1370 STEWART ST

PRIORITIES & BOARD RECOMMENDATIONS

After visiting the site, considering the analysis of the site and context provided by the proponents, and hearing public comment, the Design Review Board members provided the following siting and design guidance.

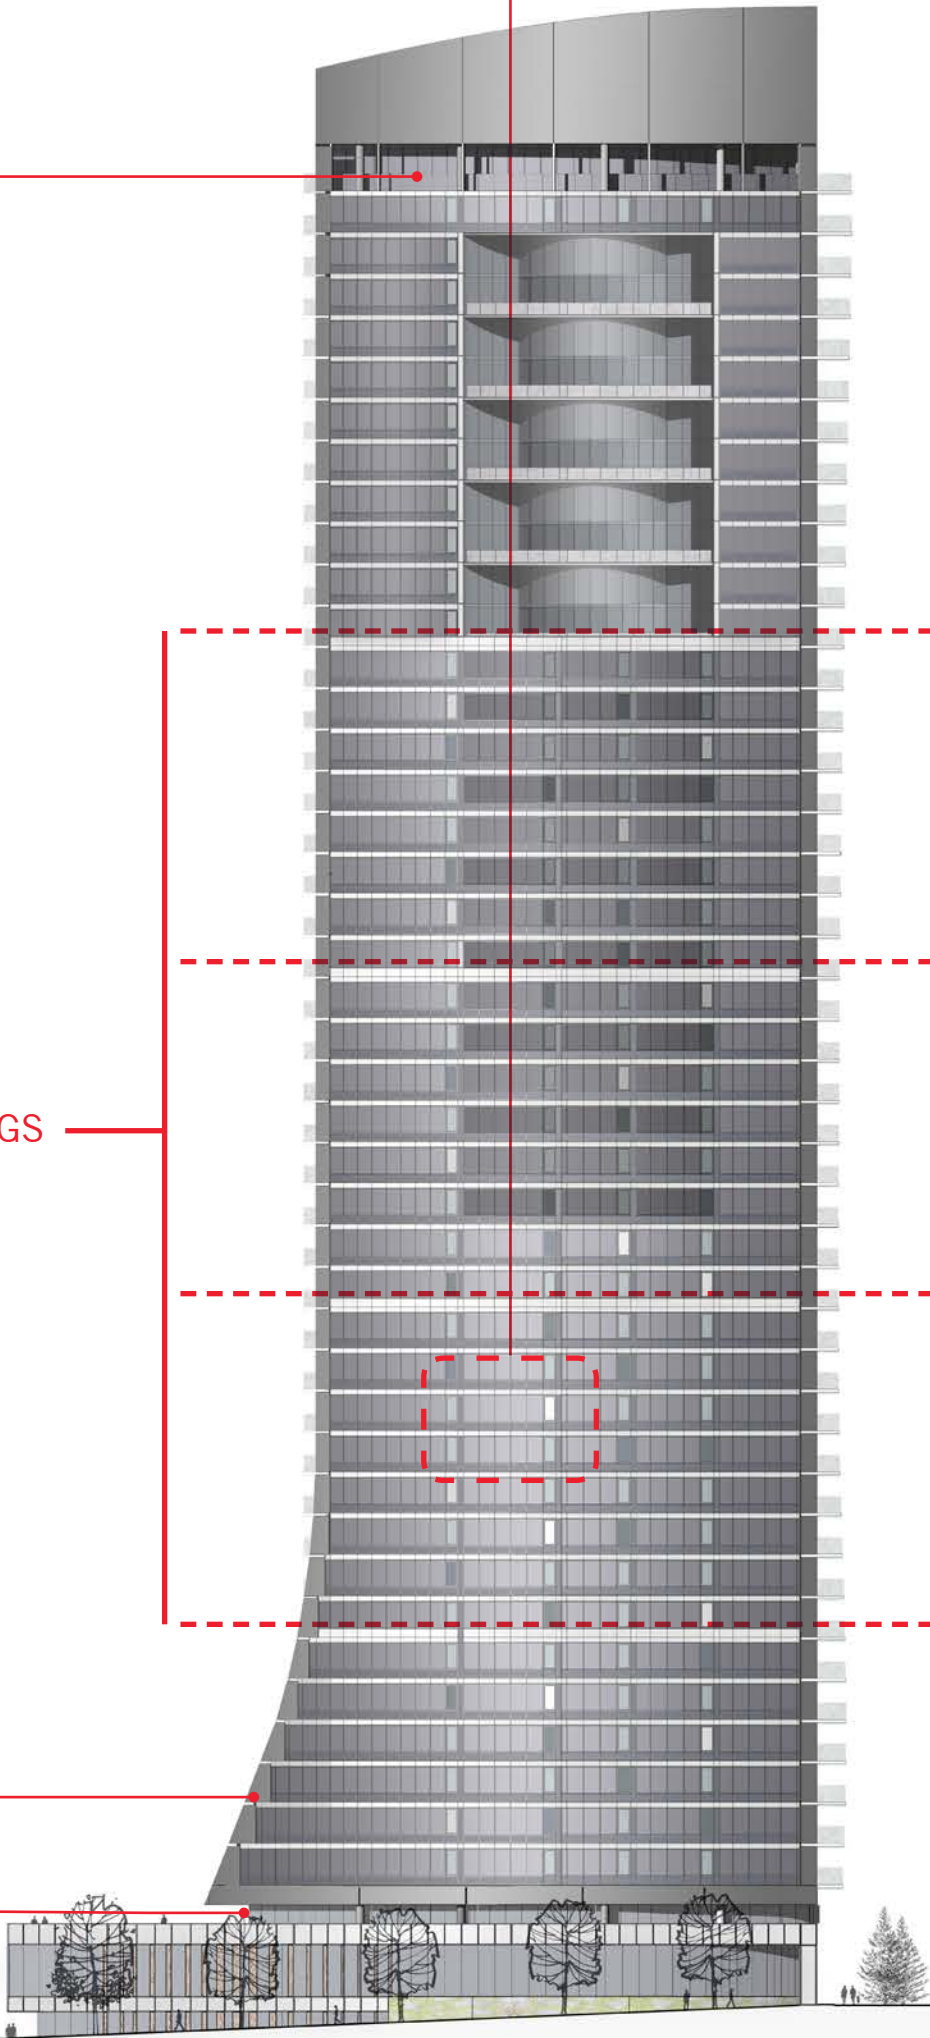
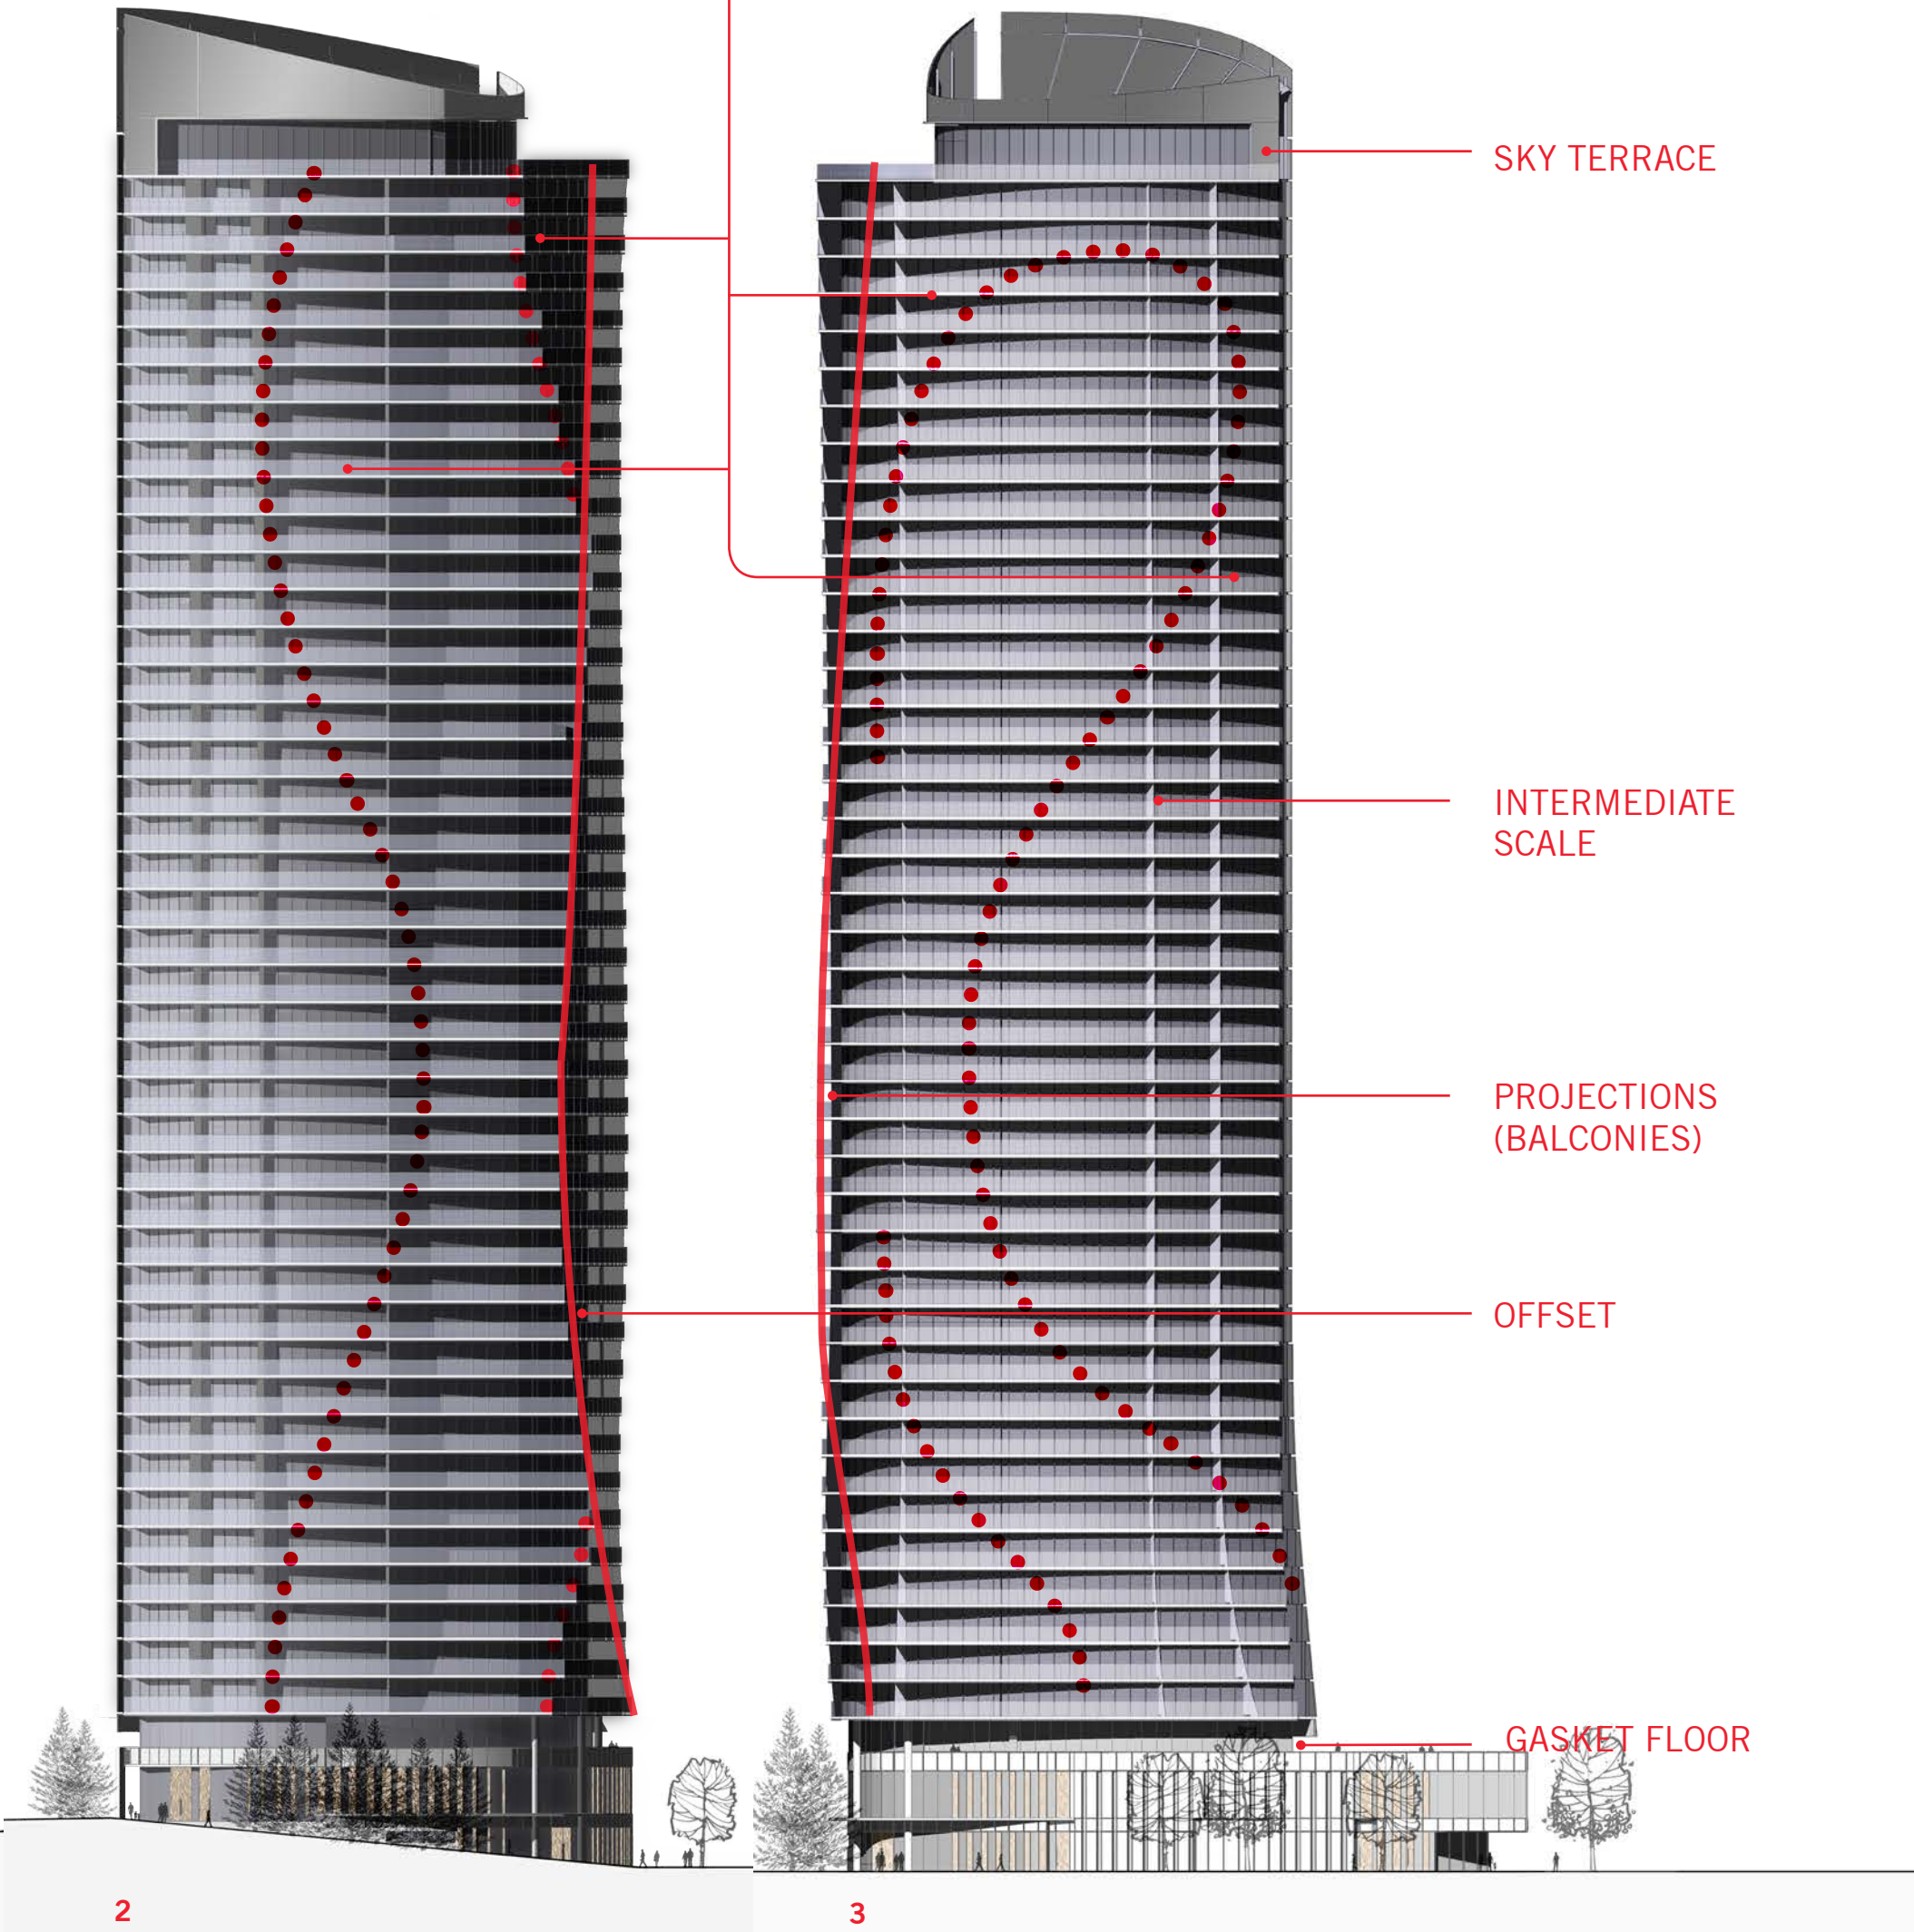
- 2A. The Board expressed their appreciation for the conceptual thinking behind the tower form and found the preferred scheme to be logical, simple and elegant. (DC2- A, DC2-1)
- 2B. The Board pointed out how the change in cladding and strong horizontal banding on the east facade had created intermediate scale elements (as called for in the SLU guidelines) and asked that the other two (north and west) elevations also include intermediate scaling elements (though not necessarily the same). (DC2-4-d., DC2-1, DC2-B, DC2-C)
- 2C. The Board was concerned that the contrast between the east-facing façade and the two west-facing facades was so strong as to seem disconnected and asked that this contrast be resolved as the design evolves. (DC2-B, CS3)

Undulating projections and offsets form a dynamic massing. An intermediate scale is organically created through floors which are grouped together from the shadows produced.

Continuity between the facades is created through the overall contemporary design language, more specifically the continuity is maintained through complementary geometry and materials.

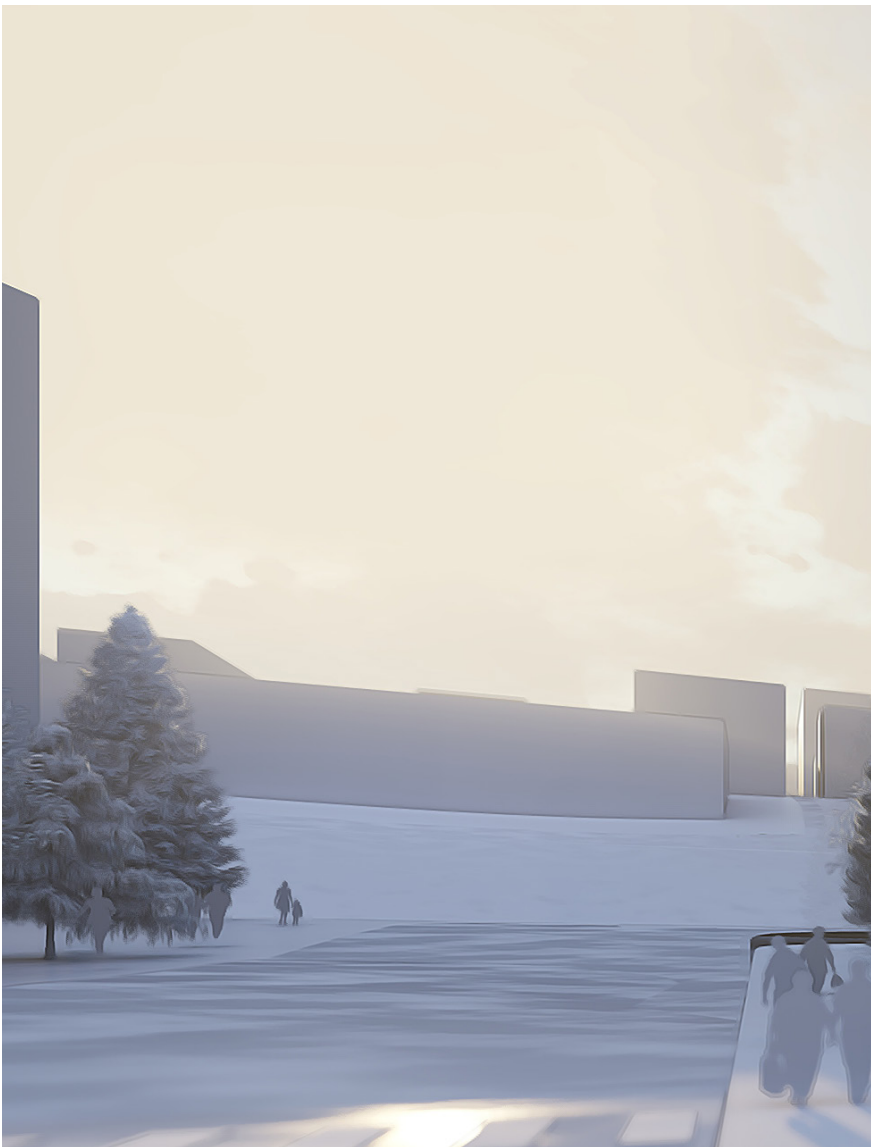
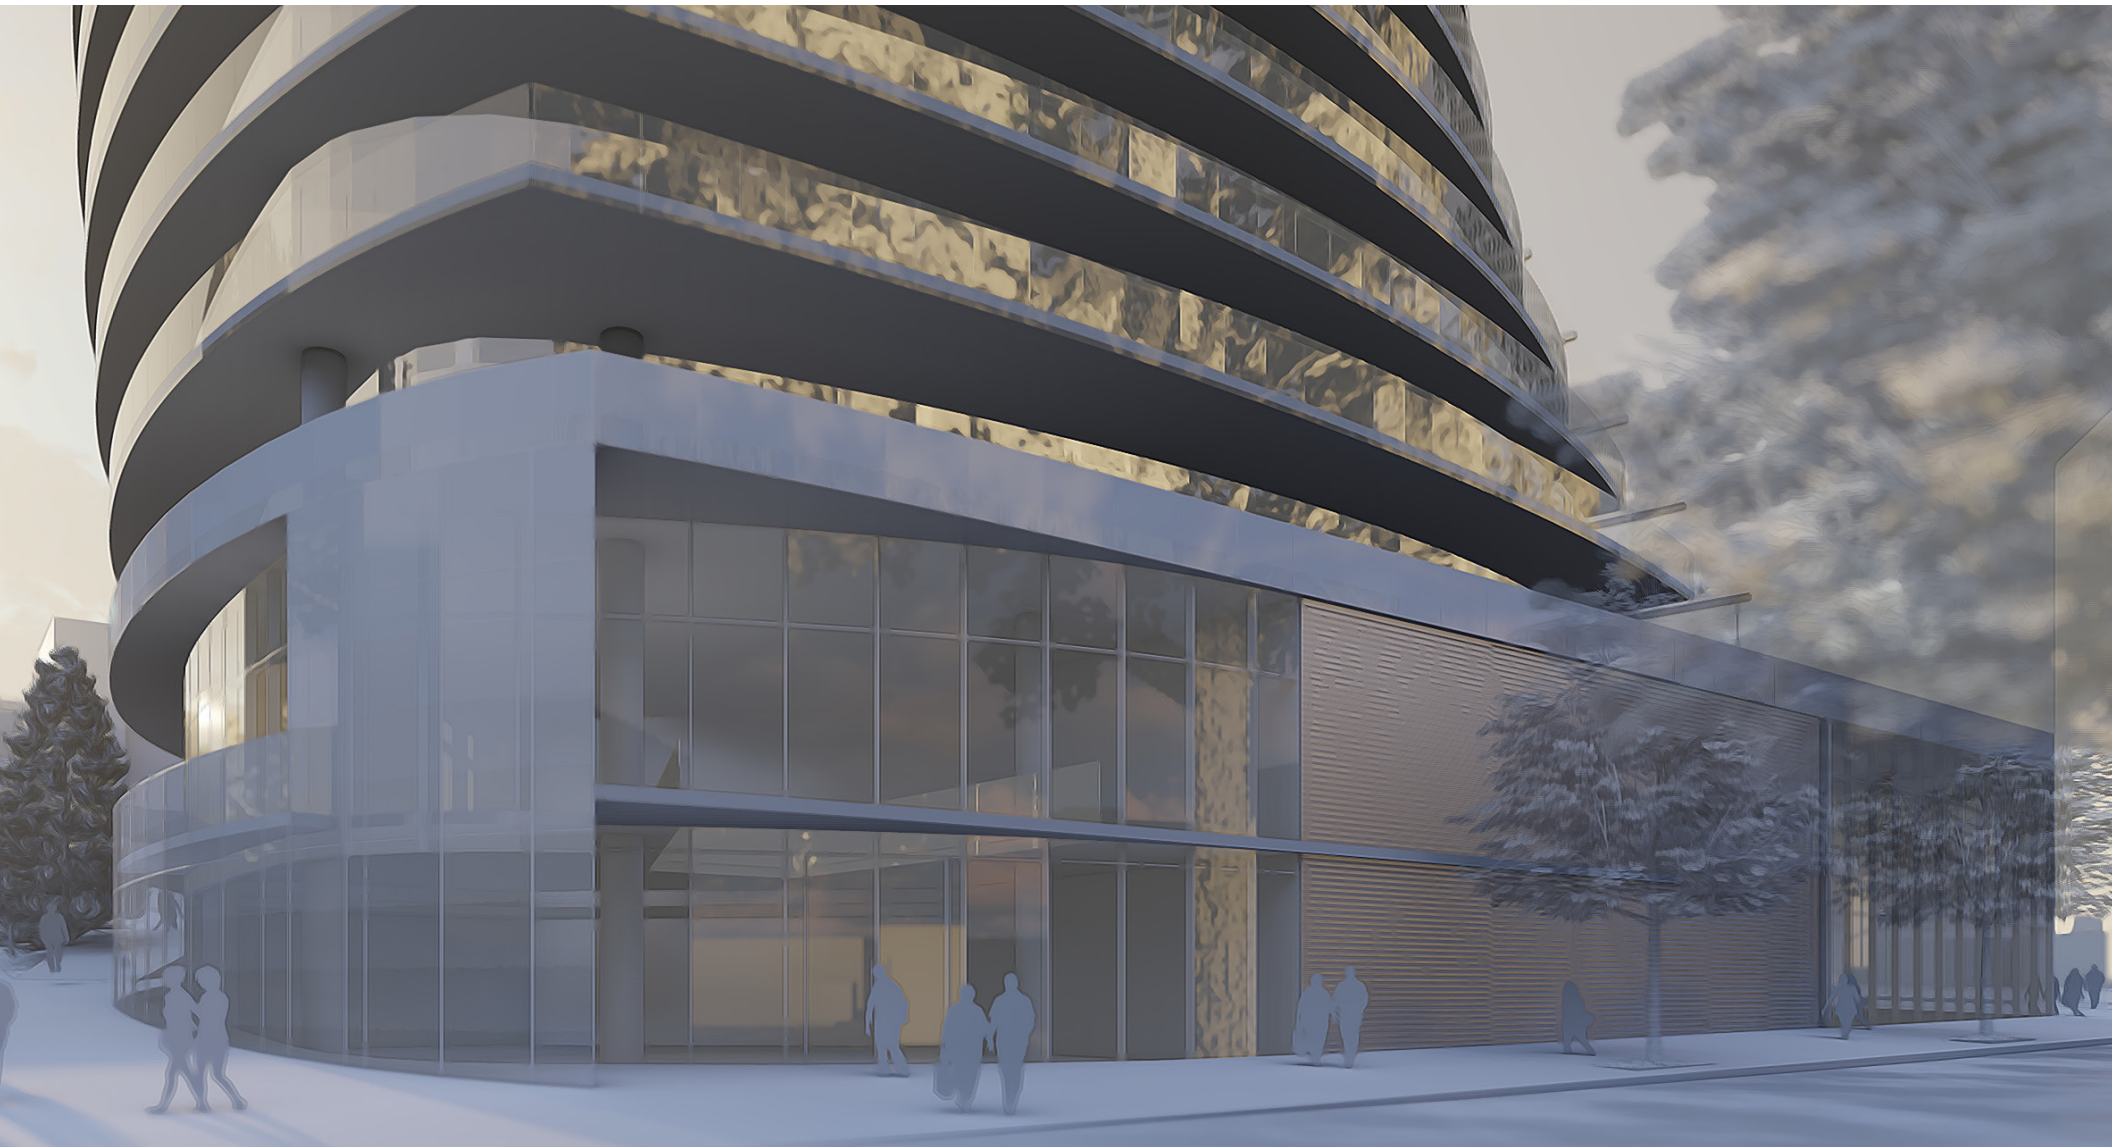
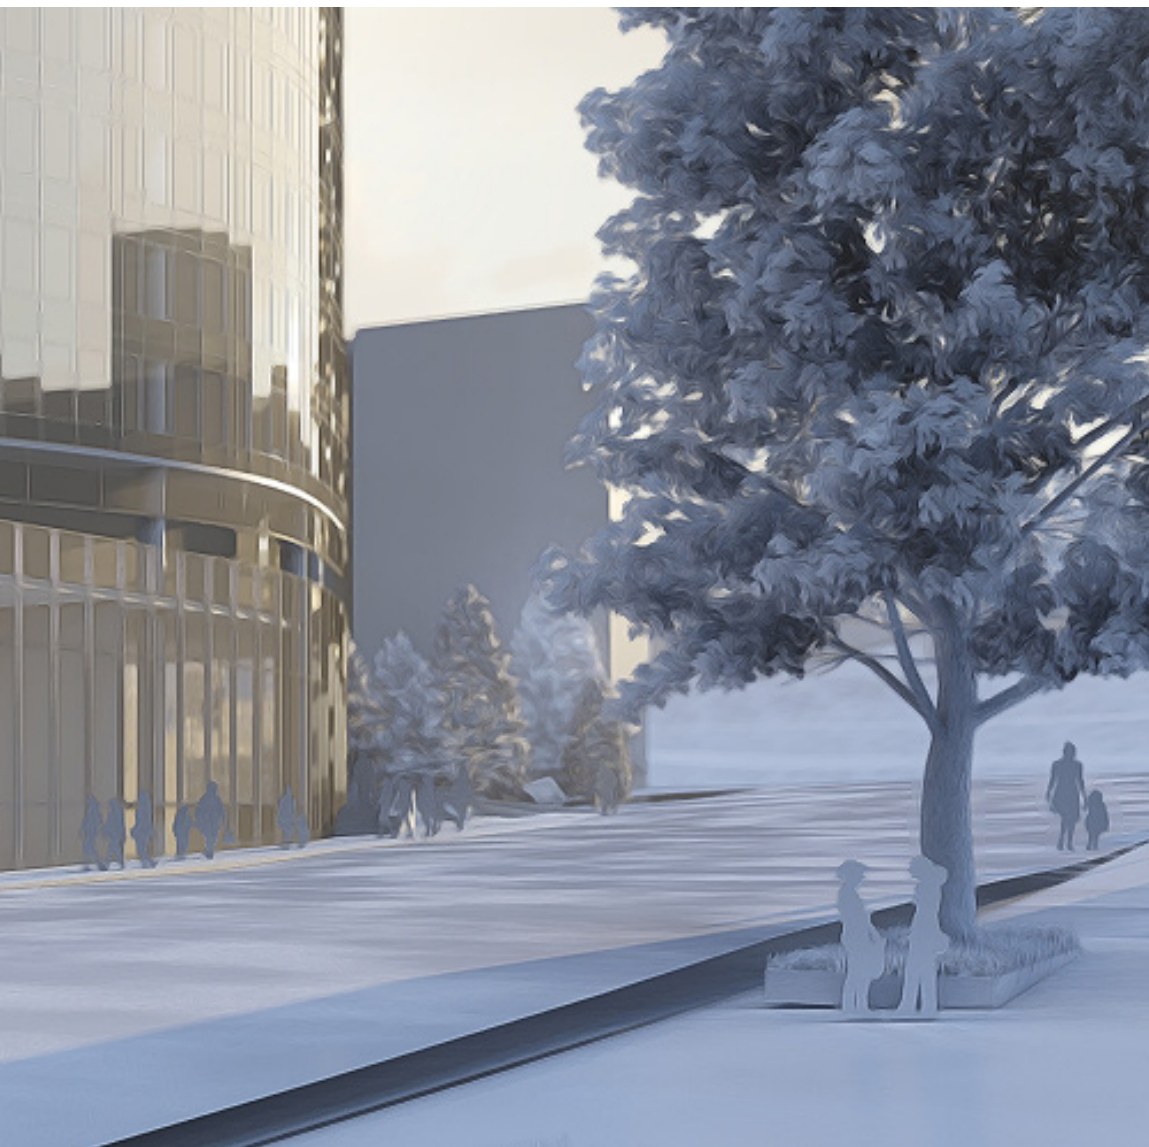
3A. The Board agreed that the northwest corner of the site will be the locus of pedestrian activity and expressed concern both that the mass of the tower is concentrated at this corner and that the podium-tower relationship is weakest here.(CS2-4, DC2-4)

- i. The Board did not support the tower coming to grade at this corner as the important scaling element of the podium would be lost. (DC2-3-a)

1. Express Podium / Response to Context
2. Facade Depth & Articulation
3. Exposed Columns
4. Canopy - Human Scale Elements
5. Pedestrian Oriented / Building Open Space Relationship
6. Intermediate Scales
